Official Transcript of Proceedings
NUCLEAR REGULATORY COMMISSION

Title: Advisory Committee on Reactor Safeguards

Date: Wednesday, December 2, 2020

New Design Review Standard for Chapter 7
 (Instrumentation and Control - I&C): Lessons Learned
 as a Result of Recent New Reactor Licensing Reviews
 Related to I&C

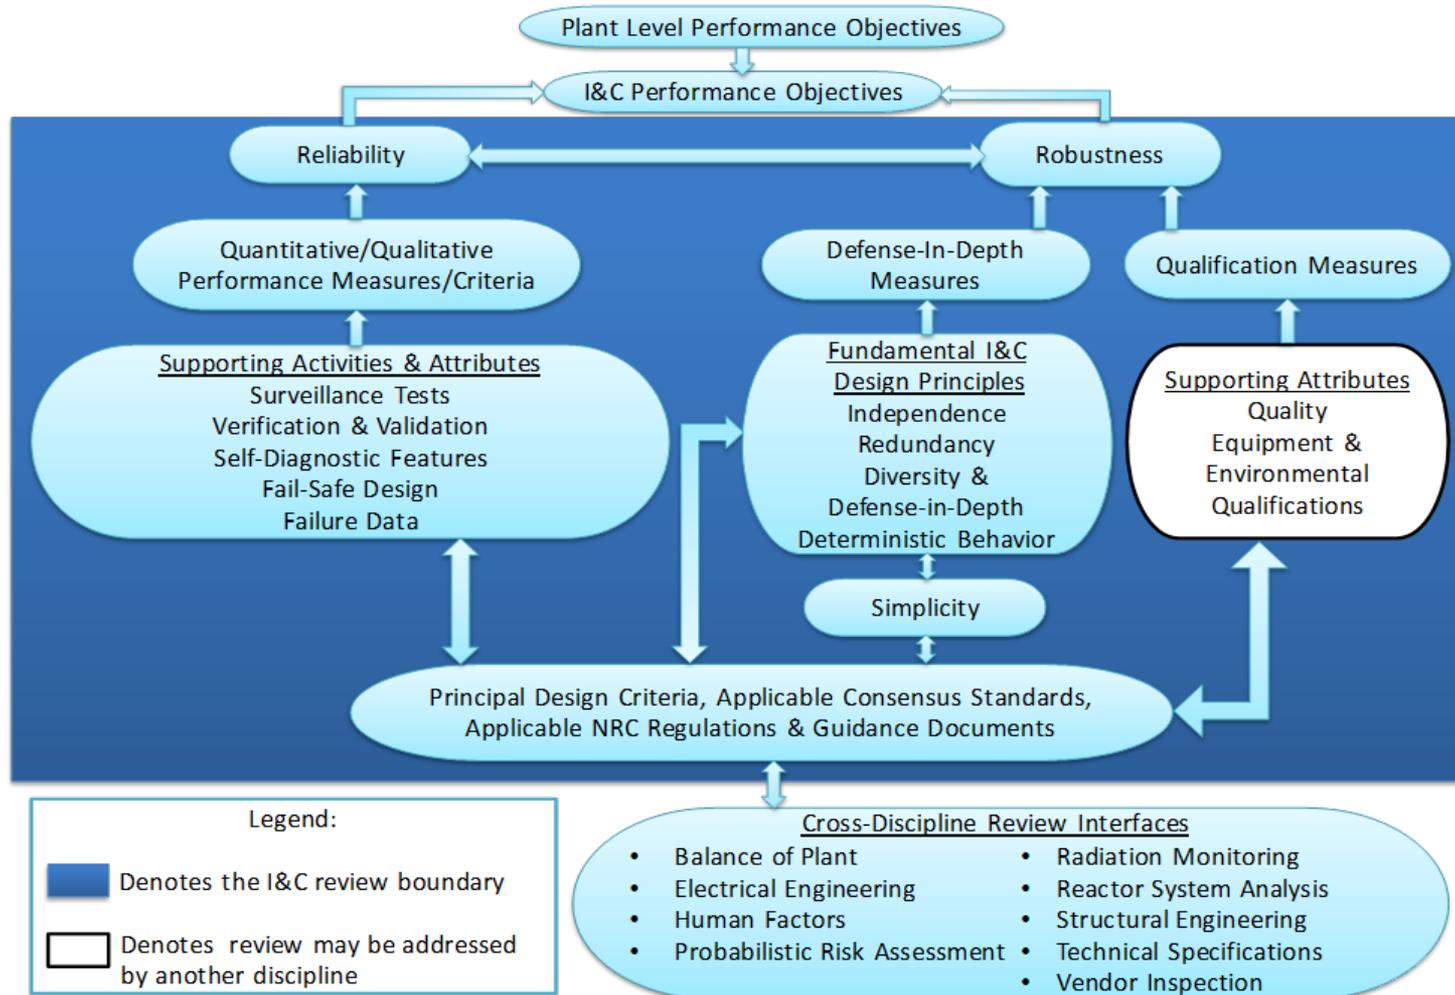
14 So next slide, please? So this is sort of
15 the I&C framework. And if you look at the top two
16 levels above the blue box, they're performed by the
17 Core Review Team with I&C support as necessary. This
18 review will formulate what is required for the I&C
19 staff to evaluate and the I&C reviewer would focus on
20 verifying the applicable attributes of the I&C design
21 that supports the plant-level performance objectives
22 as depicted by the Core Review Team.

23 So the blue box depicts the flow of the
24 review, the full I&C review. The I&C staff will be
25 evaluating that the demonstration -- that the I&C

19 The figure was revised to show that the
20 fundamental I&C principles show up, so one of our
21 previous Subcommittees -- the blue box in the center
22 -- or this bubble in the center of the blue box would
23 identify the I&C principles for -- I mean, it was in
24 the guide but it wasn't in this figure, so we just
25 added them. So the I&C reviewer should confirm that

7 And finally, the I&C should interface with
8 other technical disciplines to verify that any cross-
9 disciplines issues are adequately identified and
10 resolved. And that's shown in this bottom bubble
11 below the blue box. So and one of the things we
12 learned with the DSRS we needed better coordination
13 with all the other chapters. I mean, we had it
14 before, but we really started creating more meetings
15 to discuss their issues and our issues and how they
16 conflict with one another. So we just carried that
17 forward and it worked out well.
